# UNITED STATES PATENT AND TRADEMARK OFFICE

APPLICATION NO.	FILING DATE	FIRST NAMED INVENTOR	ATTORNEY DOCKET NO.	CONFIRMATION NO.
10/790,392	03/01/2004	William L. Grilliot	MOR3334P1071US	2675
32116	7590	01/25/2005	EXAMINER	
WOOD, PHILLIPS, KATZ, CLARK & MORTIMER 500 W. MADISON STREET SUITE 3800 CHICAGO, IL 60661			WELCH, GARY L	
			ART UNIT	PAPER NUMBER
			3765

# Office Action Summary

**Fig. 4**

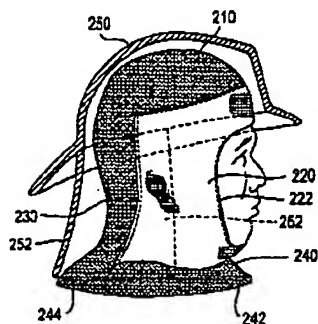
Figure 4 of Lewis et al. shows the garment 200 worn in combination with a firefighter's helmet 250. Therefore, since the wearer's head is protected with a helmet 250, the top portion of the garment 200 is manufactured from same material as the back

portion 230. However, it would have been obvious to one of ordinary skill in the art at the time the invention was made to increase the wearer's protection by increasing the coverage of the fluid impervious, heat reflective layer nearer the top of the garment 200.

With regard to claim 2, the heat reflective layer is continuous from a region at or near one side of the front portion 220 to a region at or near the other side of the front portion 220 (see Figure 4 where layer extends from right side seam, across face to left side seam).
